## T-046 SERVICE BULLETIN

### Rework of E6899081 Combustion Liner for C28 Installation

<b>Engine Application(s):</b>	Allison 250-C28B, C28C
<b>Subject:</b>	Rework procedures for E6899081 Combustion Liner to improve part durability and improved burner outlet temperature in Series III applications only.
<b>Compliance:</b>	Customer option.
<b>Revisions:</b>	N/C Dated: 9/18/98 Original issue. A Dated: 1/07/99 Page 2: .63 was .600. Page 3: Added "Dilution Chamber" to Figure 2 and 1.95±.06 was 1.50±.06. B Dated: 9/03/09 Updated EXTEX to TIMKEN. C Dated: 2/04/16 Updated Timken to EXTEX Engineered Products.

**FIGURE 1**

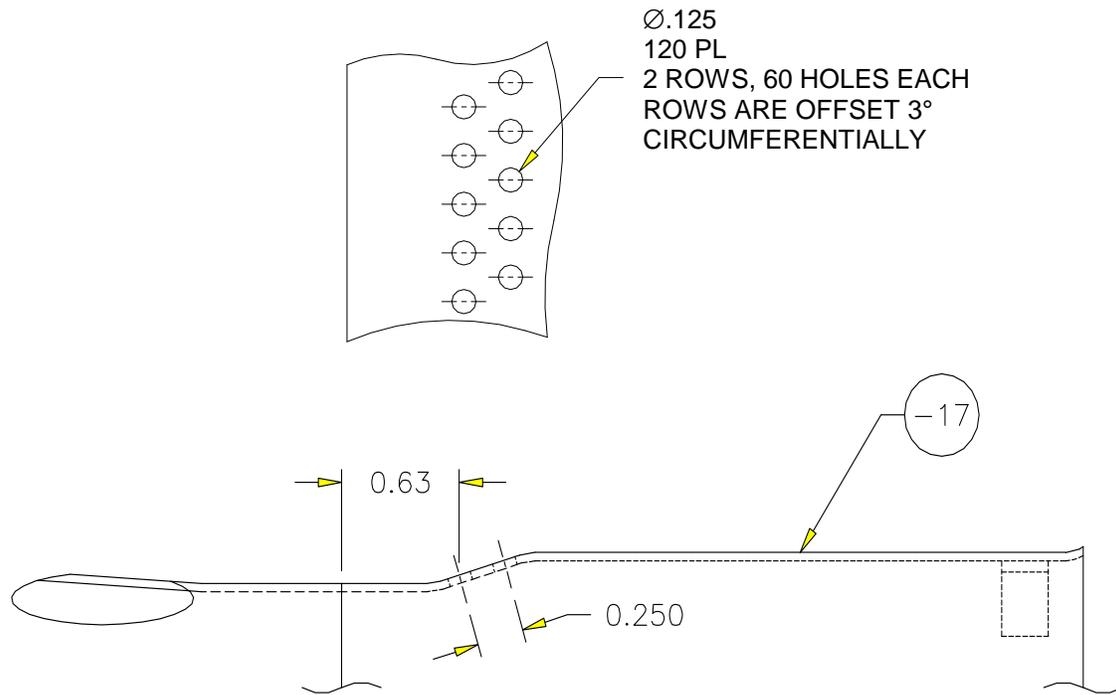
- 1.2 Add 120 holes, 0.125" diameter, located as shown in Figure 1.
    - 1.2.1 Any suitable method may be used to add the holes provided deformation of the -17 detail is kept to a minimum and the -10 detail is not punctured or otherwise damaged.

**FIGURE 2**

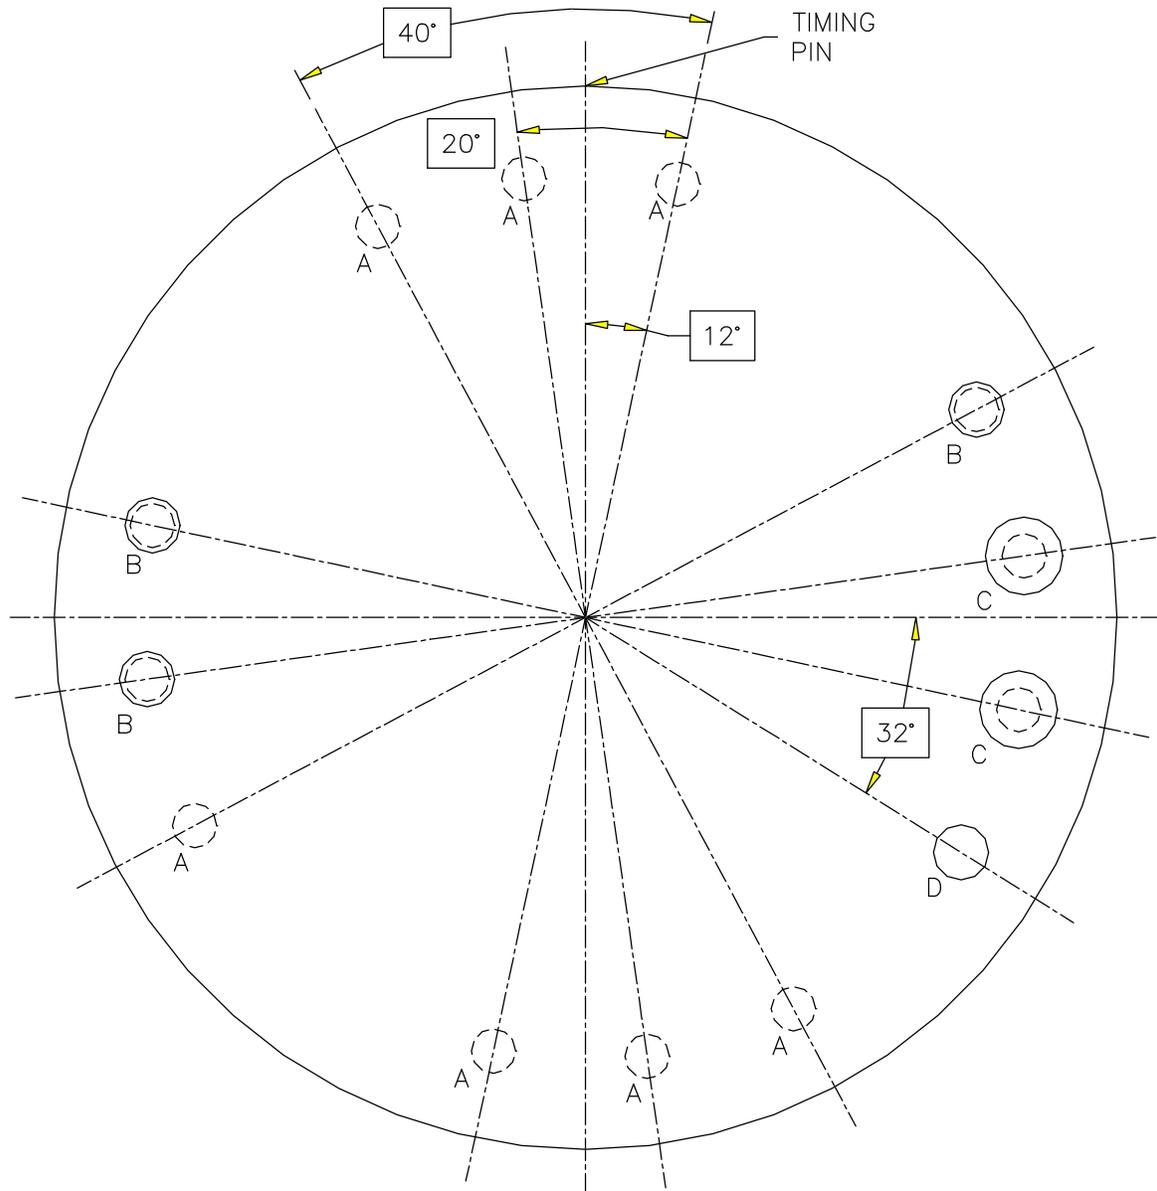
- 1.3 Fabricate seven 0.250" diameter disks, 0.038 - 0.046" thick using AMS 5536.
    - 1.3.1 Use the disks to plug the holes as shown in Figure 2. GTAW Class II plugs in place all around per MIL-STD-2219 using AMS 5786 or AMS 5798 weld rod. Grind excess weld flush on both sides. Maximum reduction of parent material thickness after grinding: 0.005".

- 1.3.2 Enlarge the three holes from 0.245 - 0.255" to 0.310 - 0.319" diameter as shown in Figure 2.

- 1.3.3 Enlarge the two holes from 0.245 - 0.255" to 0.436 - 0.446" diameter as shown in Figure 2.
- 1.3.4 Add one 0.310 - 0.319" diameter hole as shown in Figure 2.
- 1.3.5 FPI welded plugs per AMS 3155, Method B.
- 1.4 Obliterate old P/N E6899081 and re-identify as E23008614 per AS478-3B1 (manual vibropeen).

- A -** Plugged holes
- B -** Holes enlarged to  $\text{Ø}.310 - .319$
- C -** Holes enlarged to  $\text{Ø}.436 - .446$
- D -** New hole,  $\text{Ø}.310 - .319$

**NOTE:** Centers of all holes must be .06 OTP of basic angular locations and  $1.95 \pm .06$  from aft end of detail.
